**RE: Winrock Town Center Park
2100 Louisiana Blvd.
Grading and Drainage Plan Stamp Date: 3/5/21
Hydrology File: J19D058G**

Based on the submittal received on 3/5/21, the Rough Grading Plan cannot be is approved for Grading Permit until the following items are addressed:

PROJECT TITLE WINROCK TOWN CENTER 2100 LOUISIANA BLVD.	DRAWN BY: JOB NO.	SHEET TITLE DRAINAGE PLAN
DATE 03/05/21	SCALE AS NOTED	SHEET NO. C100

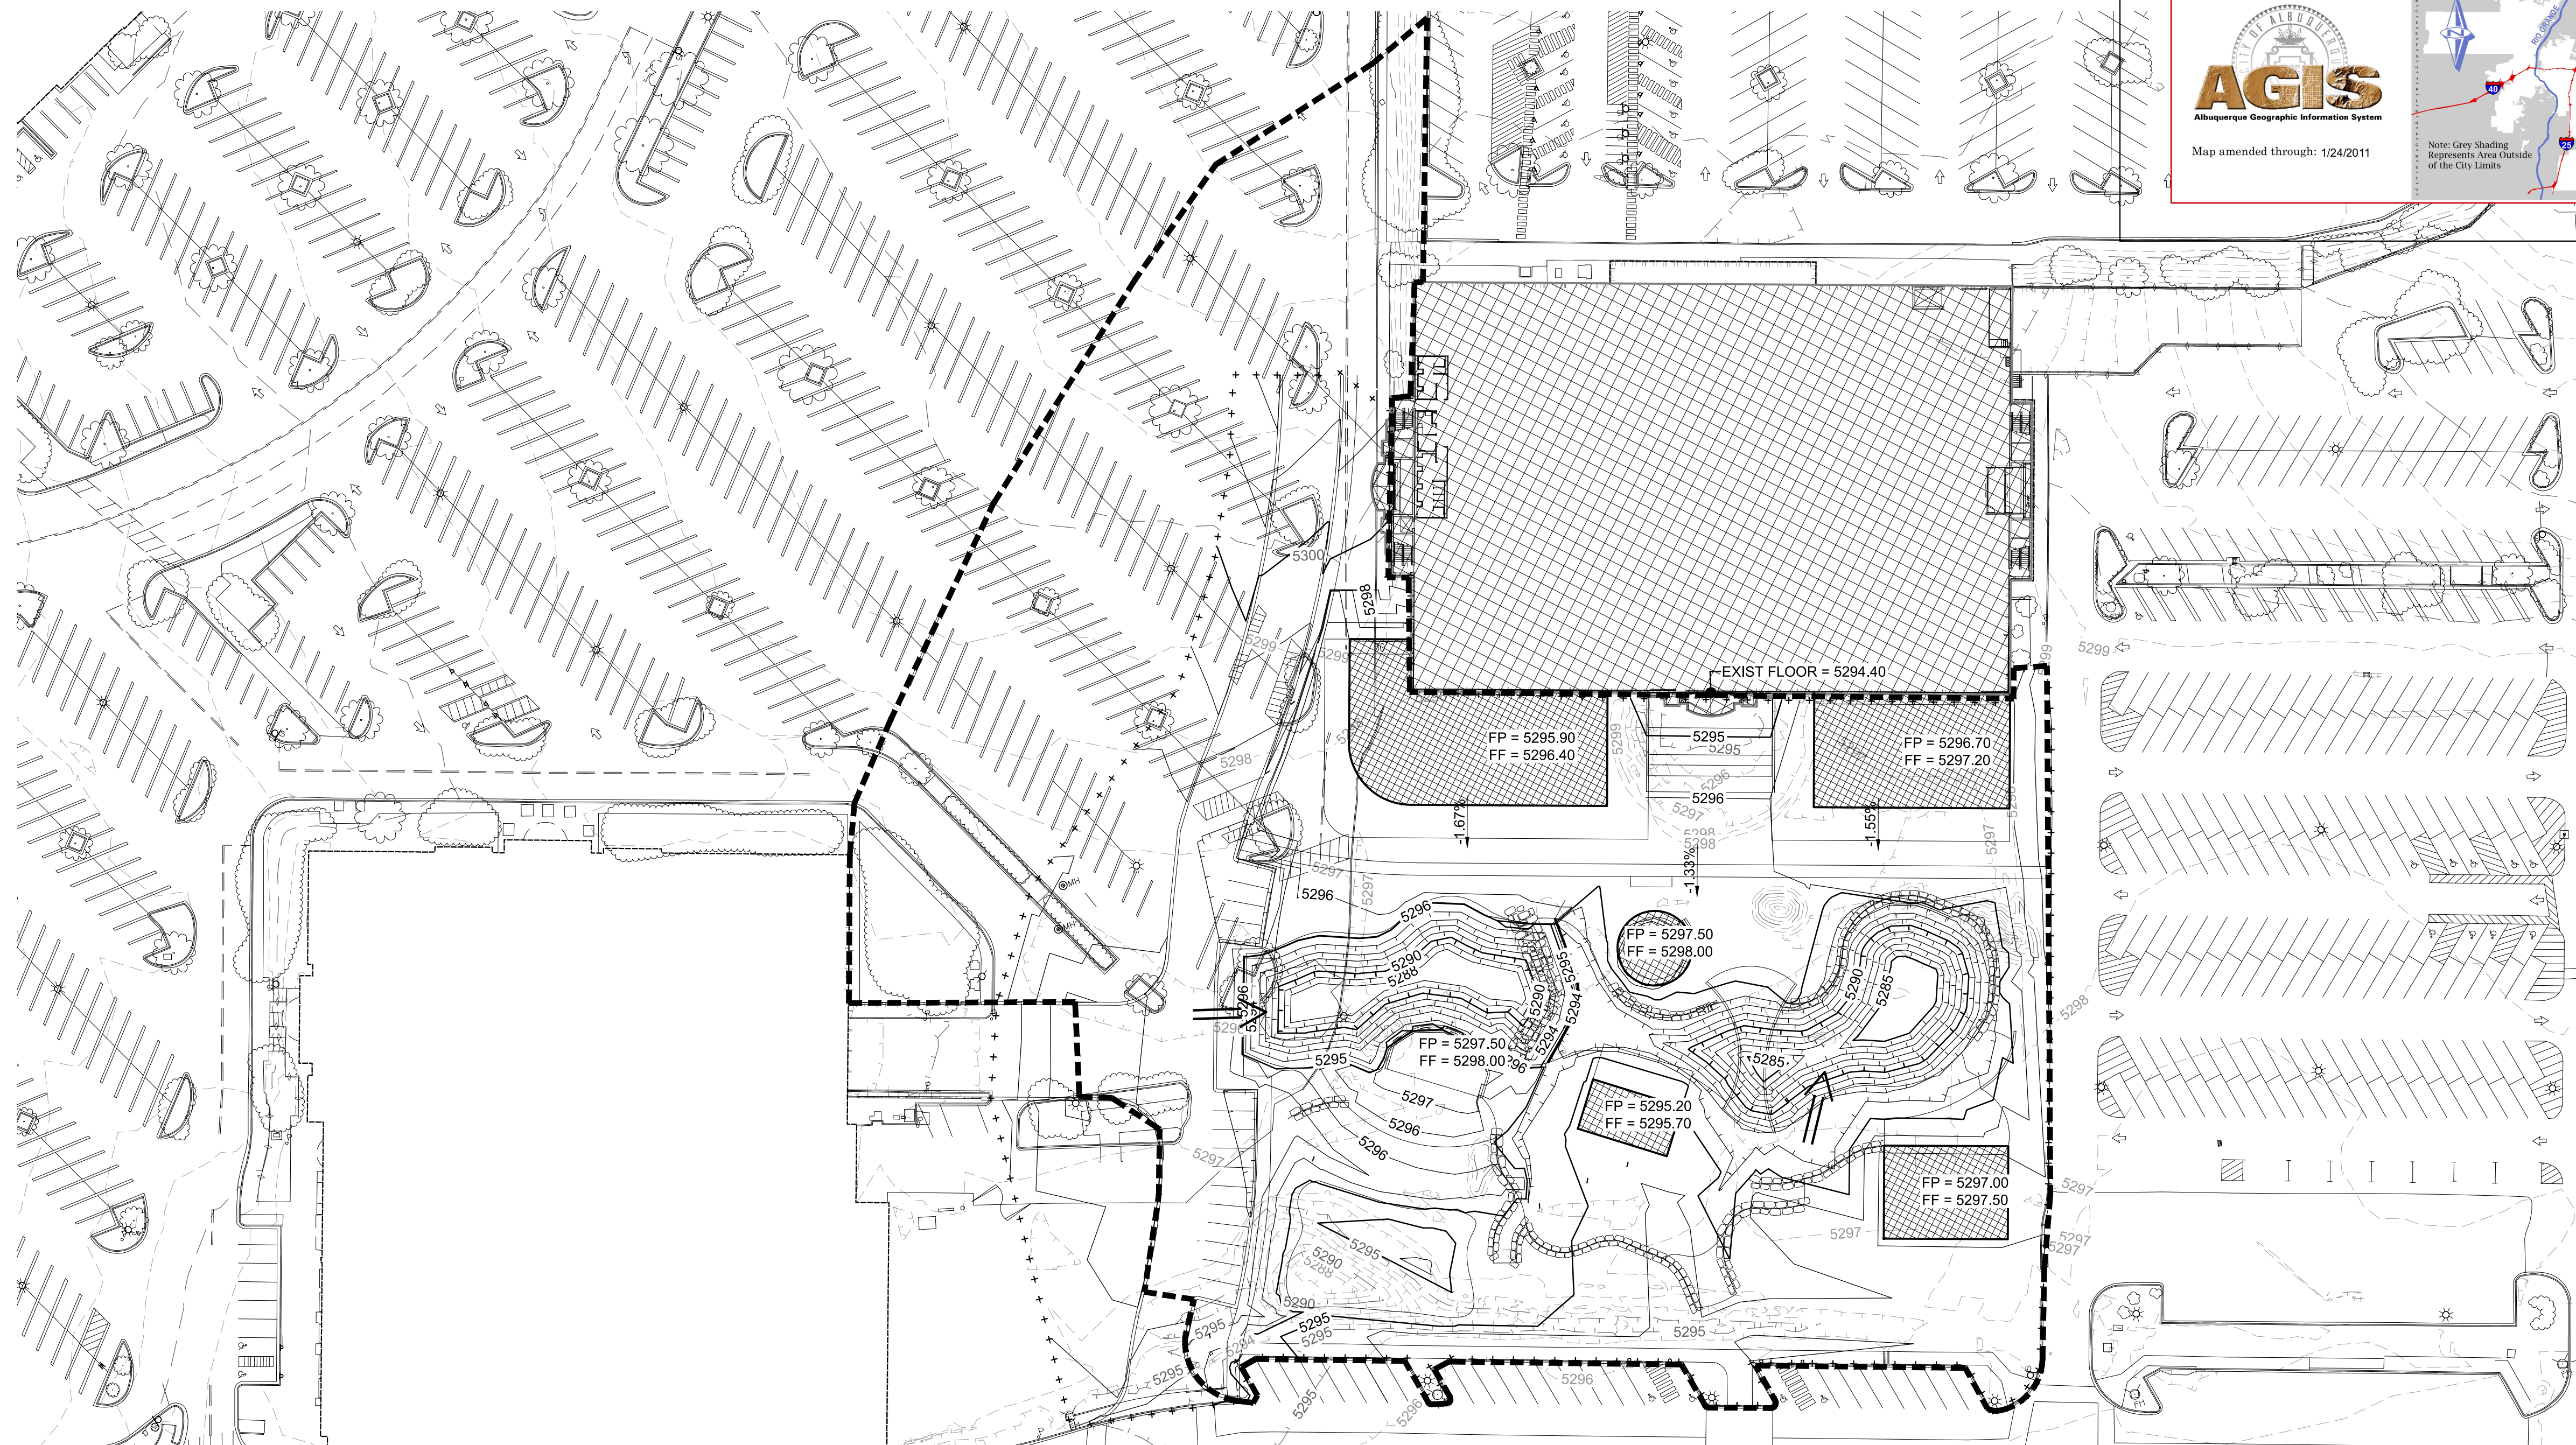
4. The section describing the proposed flows mentions an existing storm drain. Please show this on the plans, show how the flows get there and show calculations showing it is adequately sized to handle these flows.

PROJECT TITLE: WINROCK TOWN CENTER
 2100 LOUISIANA BLVD.
 PROJECT NUMBER: JOB NO. DRAWN BY:
 SHEET TITLE: ROUGH GRADING PLAN

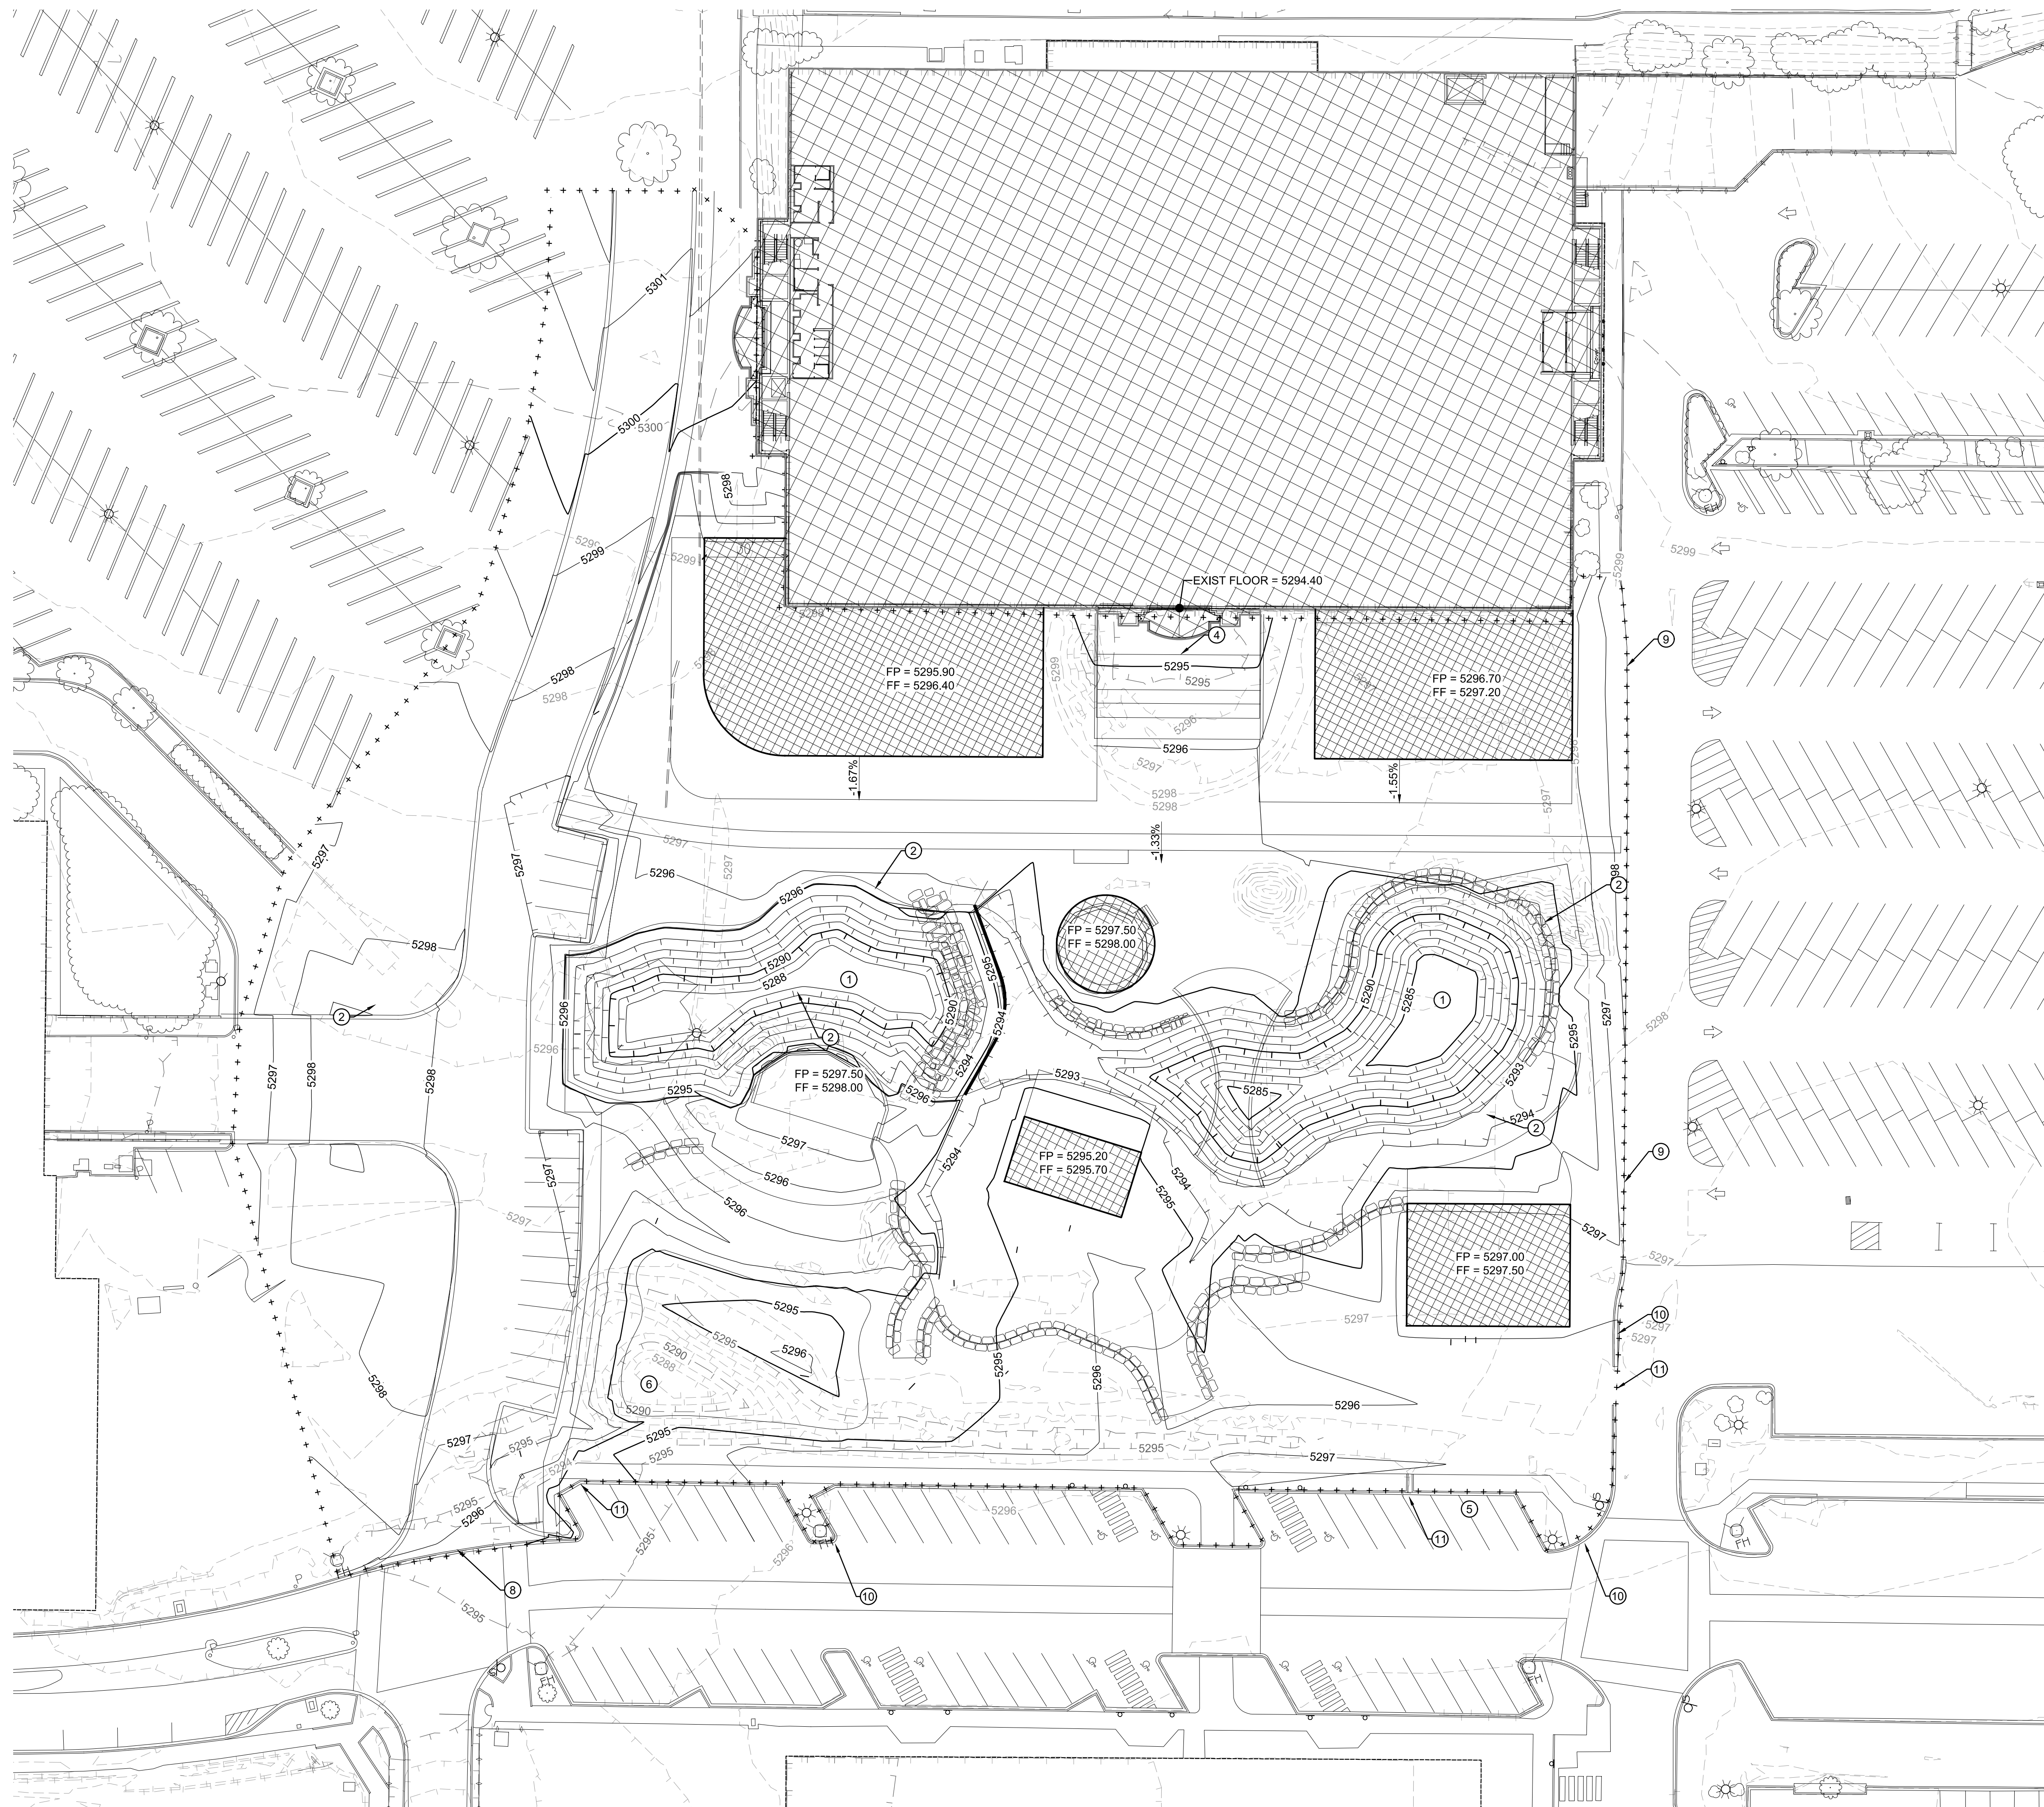
1. These plans are too vague on details. Please provide further information for review.
2. Please provide drainage basin limits with flow arrows showing storm drain runoff direction. The grading limits shown have some flows leaving the graded area and these flows need their SWQV addressed.

3. It appears the roadway and parking lot re-graded on the west portion of the graded area are blocked from the SWQ pond by curb and there are two large areas of ponding where there is parking.

5. Are the lakes planned to be filled? If so, please state the elevation they are planned to be filled to. Show the available volume for SWQ.
6. Is there a drain on the lakes? How are these to be cleaned as SWQ waters are planned to be retained in here which would create murky water.
